Addendum #1

May 3rd, 2022

Re: **Addendum No. 1**
Garner Main EMS
845 Thompson Road
Garner, NC 27529
ADW Job No. 20004
Wake County Bid #22-030

OVERALL SITE UTILITY PLAN

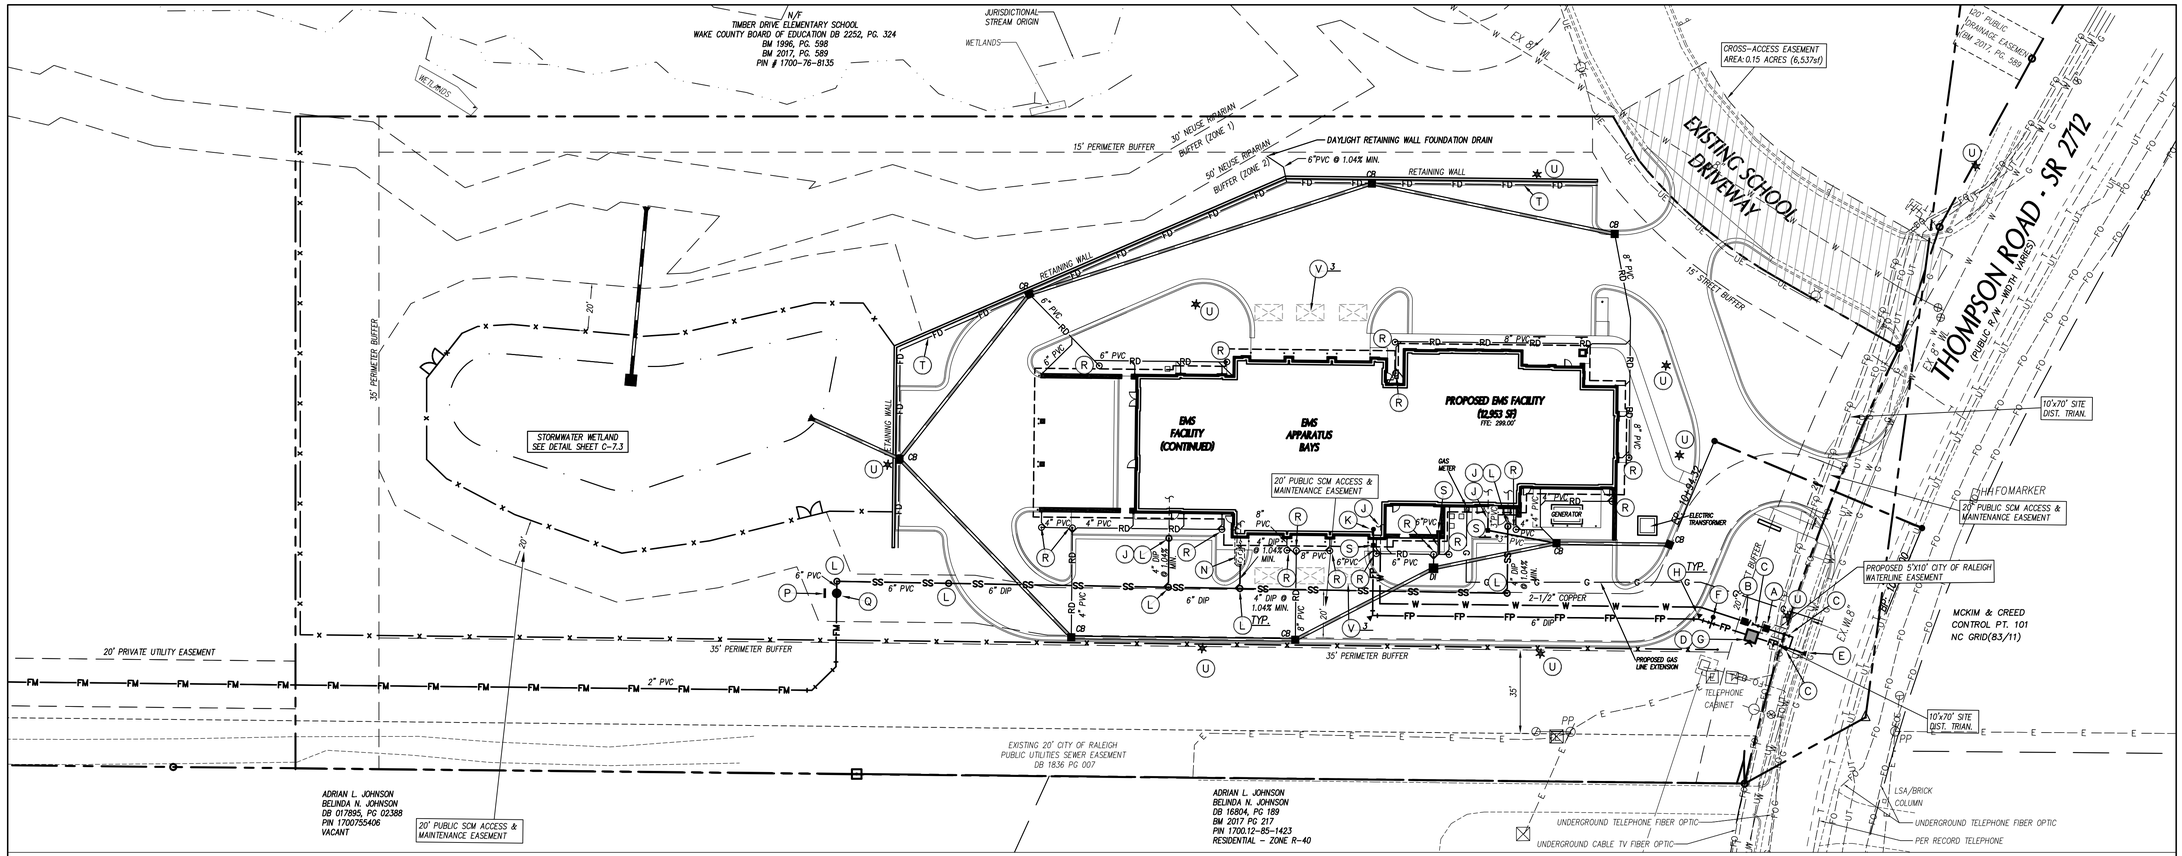
1.) Sheet C5.0:
   a. Key Notes: Note "N" has been changed to read 1,000 gallon oil/water separator, see plumbing plans.

PLUMBING WATER AND GAS FIRST FLOOR PLAN | 1/8" = 1'-0" | 01

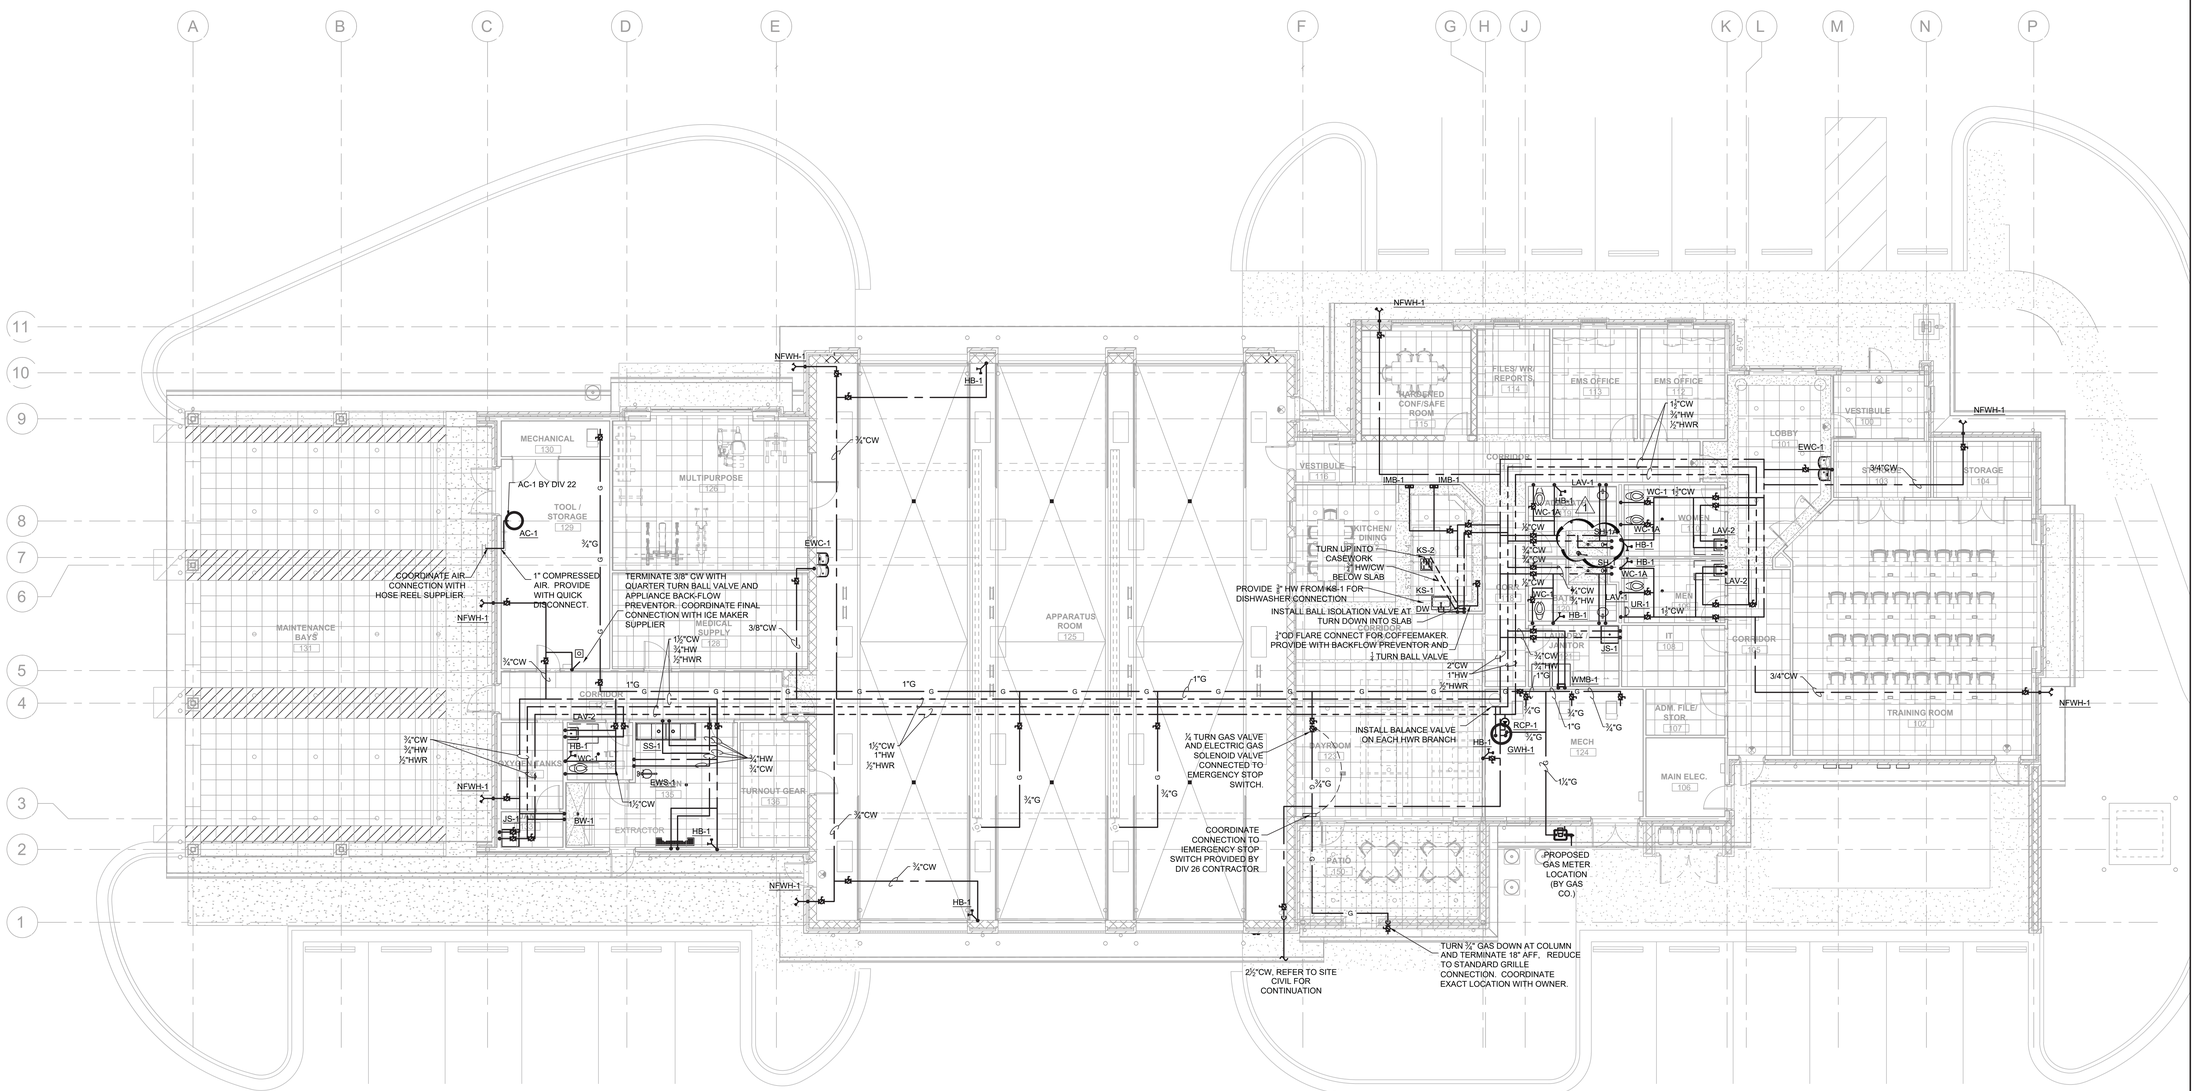
2.) Sheet P002:
    b. Remove requirement for stainless steel splash plates on JS-1. Refer to Architectural plans for finishes in this location.
    c. Fixture FS-1 is now schedule
    d. OWS-1 is not added to the Fixture schedule and detailed on P501

PLUMBING WATER RISER DIAGRAM | NO SCALE | 02

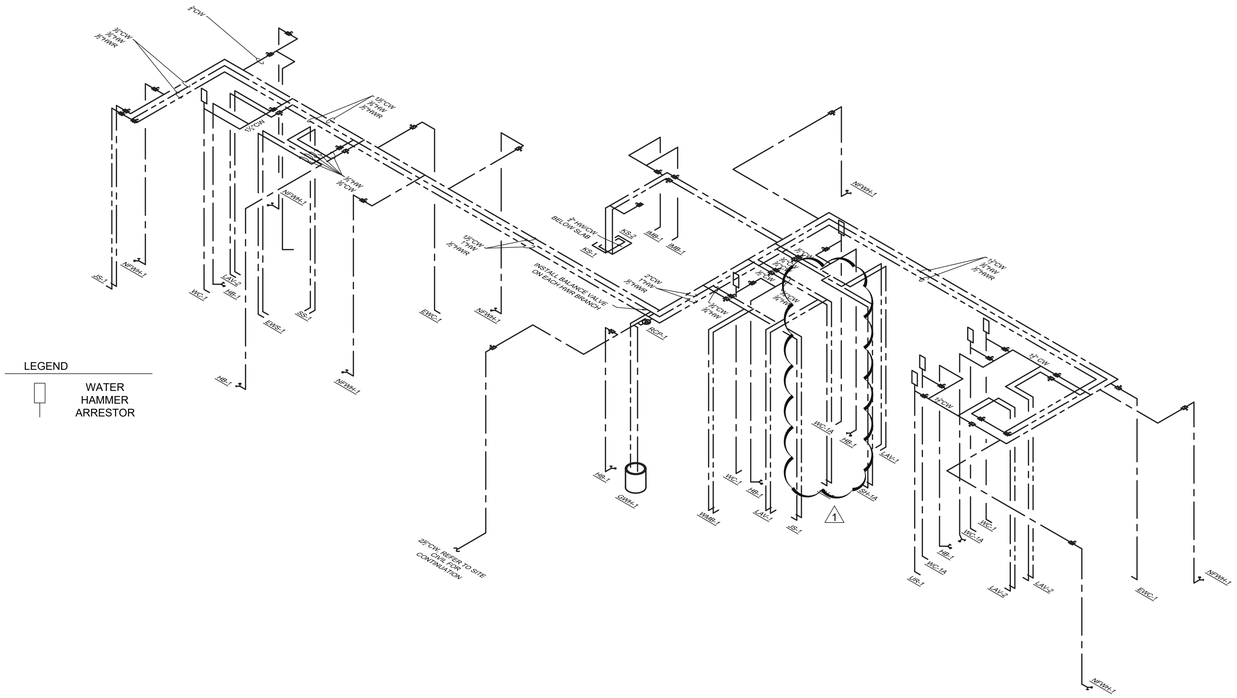
4.) Sheet P300:
    a. Removes unnecessary hot and cold water rough-ins for the extra SH-1A fixture described above from the water riser.

GRAVITY OIL WATER SEPARATOR DETAIL S-40A | NO SCALE | 01

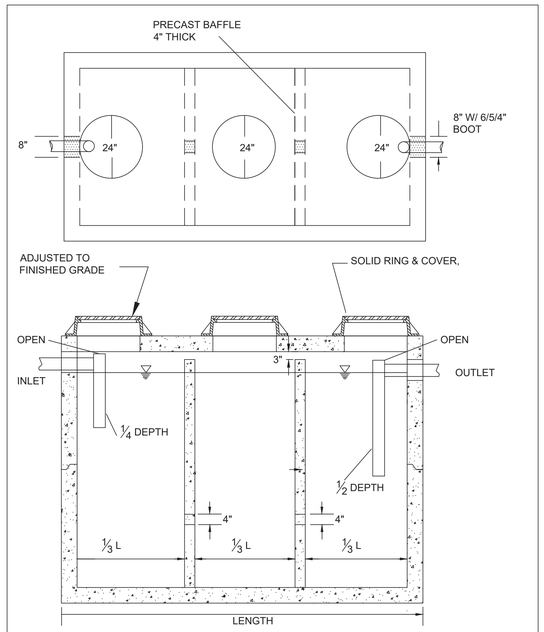
1.) Sheet P001 & new sheet P501:
    e. Delete Steel Oil Water Separator detail in its entirety. These devices shall now be a 1,000 gallon precast GI. Refer to new sheet P501 for specifications and details of new OWS-1.

TYPICAL PITCHED ROOF FLUE DETAIL | NO SCALE | 04

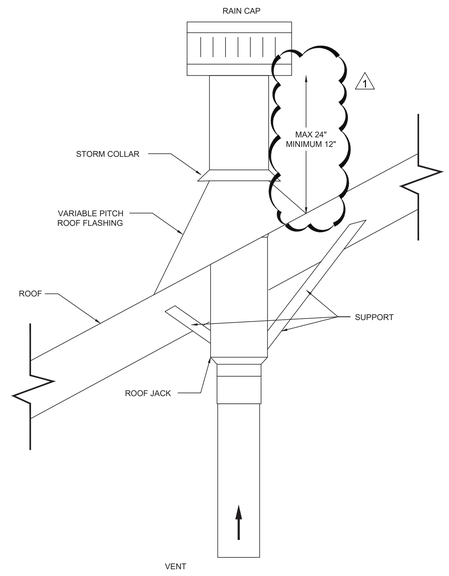
2.) Sheet 501:
    a. Detail #4: Dimension has been added to flue stack height. The outlet of the flue shall be maximum 24" from the highest pitch but not less than 12"

DUCTLESS MINI-SPLIT UNIT INSTALLATION | NO SCALE | 02

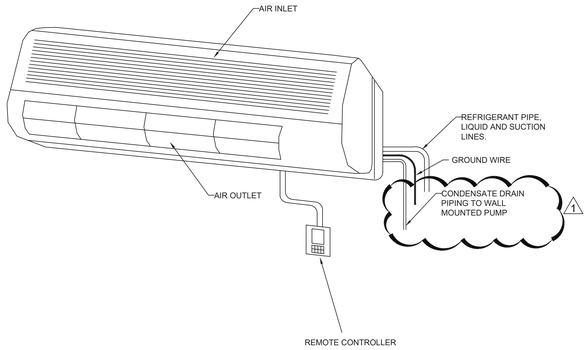
3.) Sheet 502:
   a. Detail #2: Notation has been added to specify a wall mounted sump and pump for condensate. Also, clarification has been added to route the pumps condensate discharge with line set through attic space.
4.) Sheet 502:
   a. Detail #4: Thickness of outdoor concrete pad has been coordinated. All outside pads shall comply with detail 4/M502 and shall be 6" thick.

LIGHTING PLAN | 1/8" = 1'-0" | 01

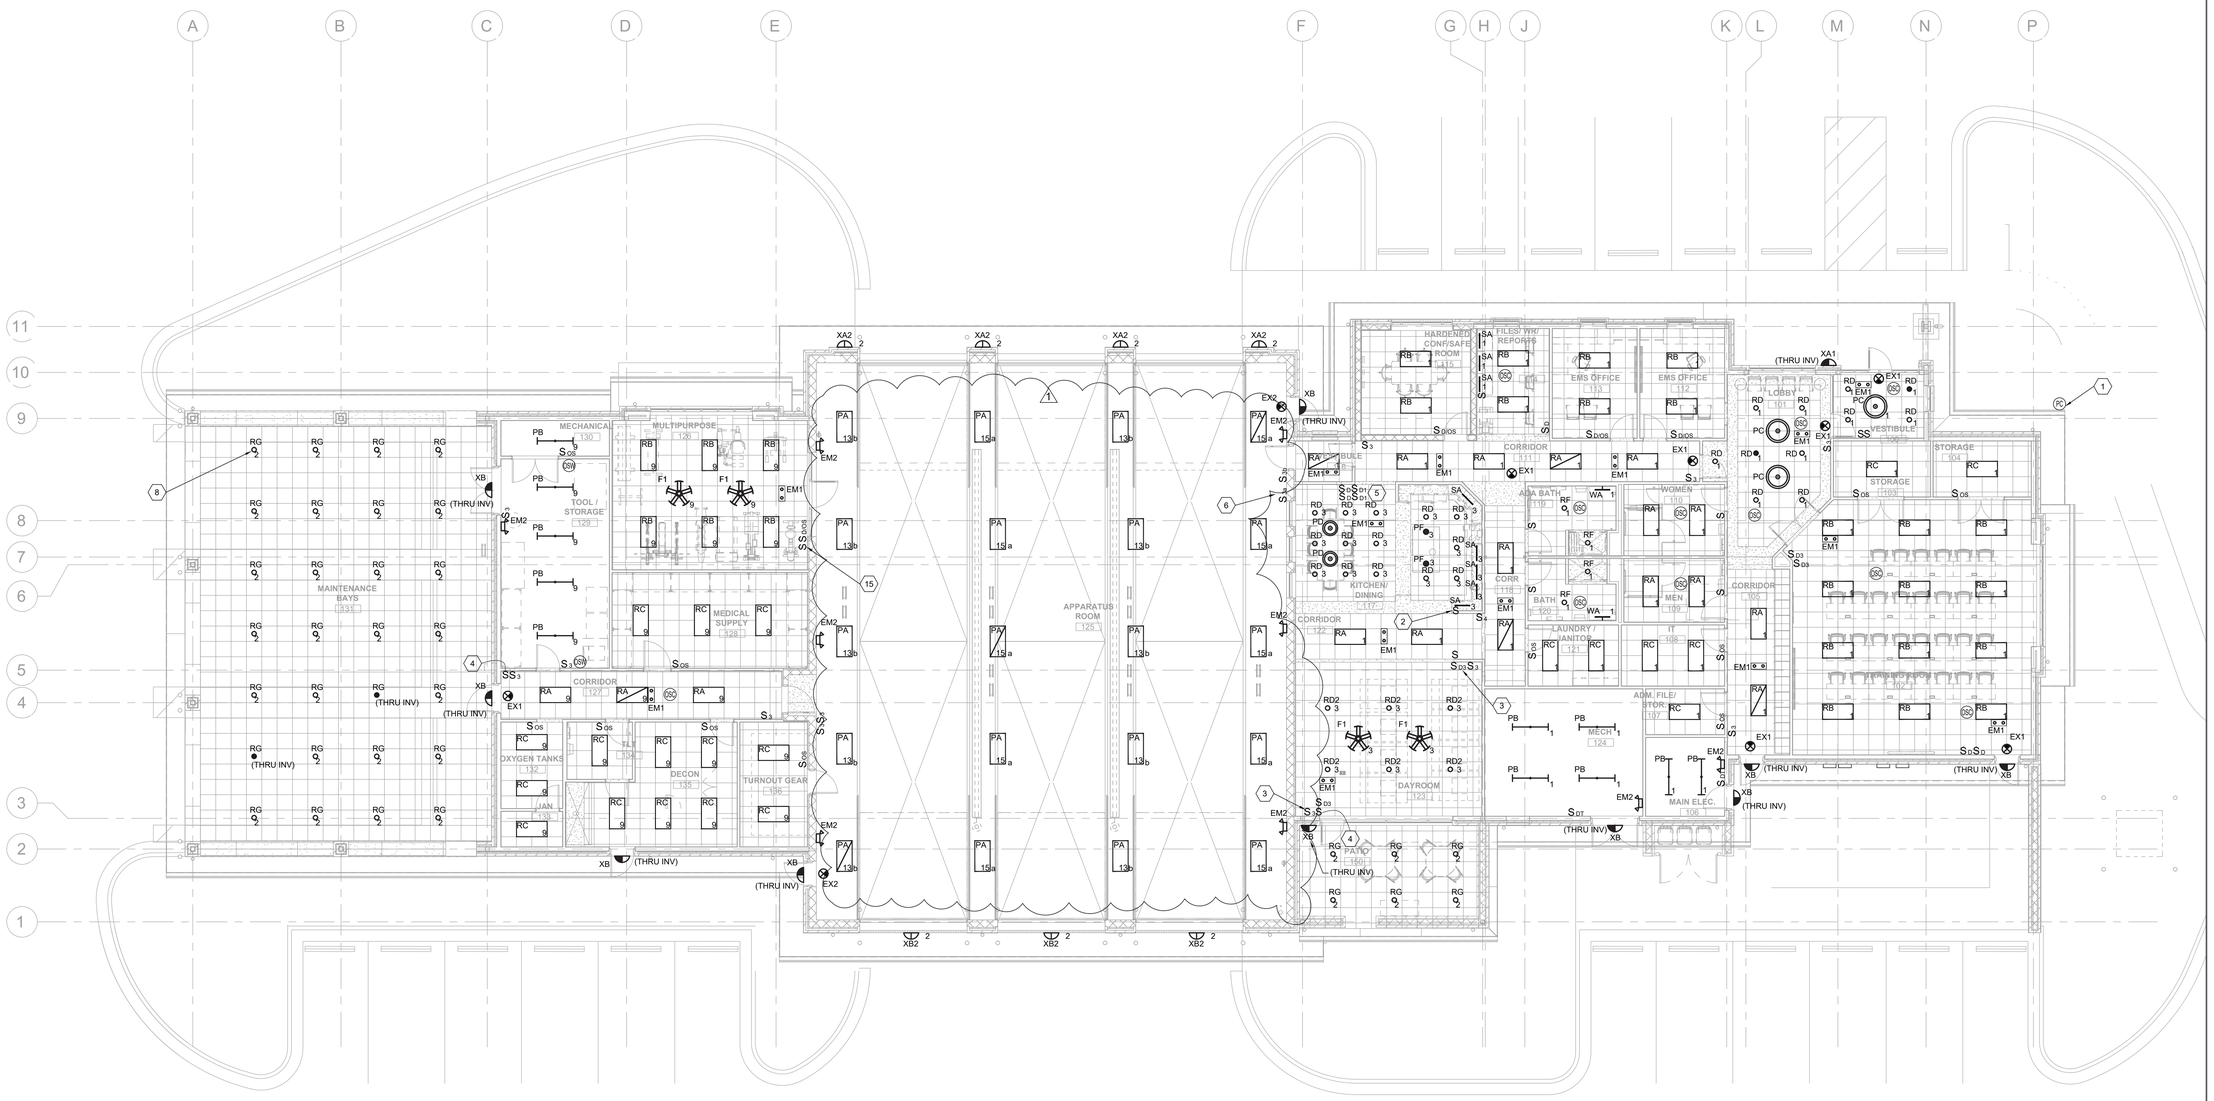
5.) Sheet E200:
   a. Changes to Bay Lighting circuiting.

POWER PLAN 1/8" = 1'-0" 01

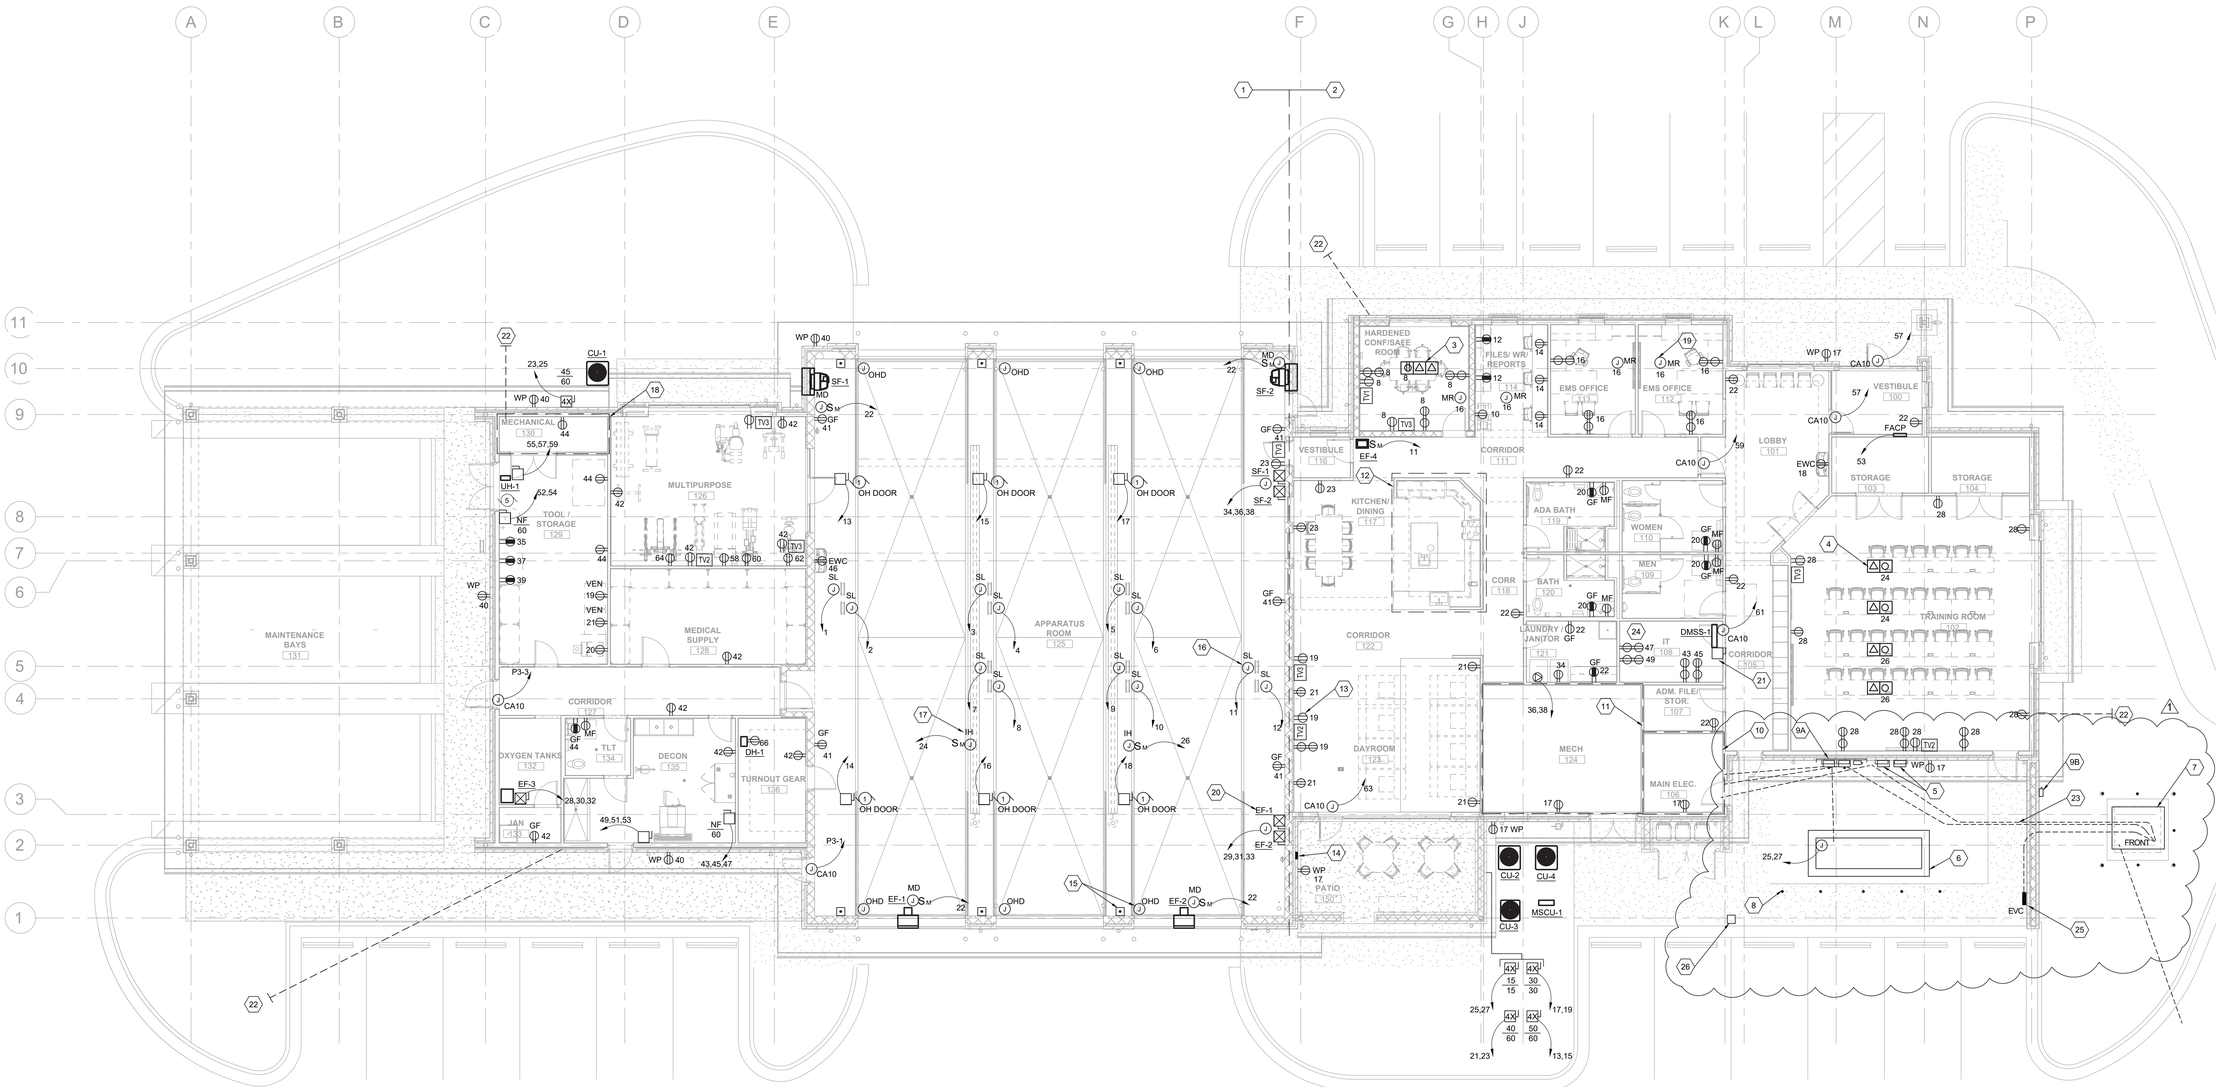
6.) Sheet E201:
   a. Miscellaneous changes related to keynotes being out of sequence and PV disconnecting scheme.
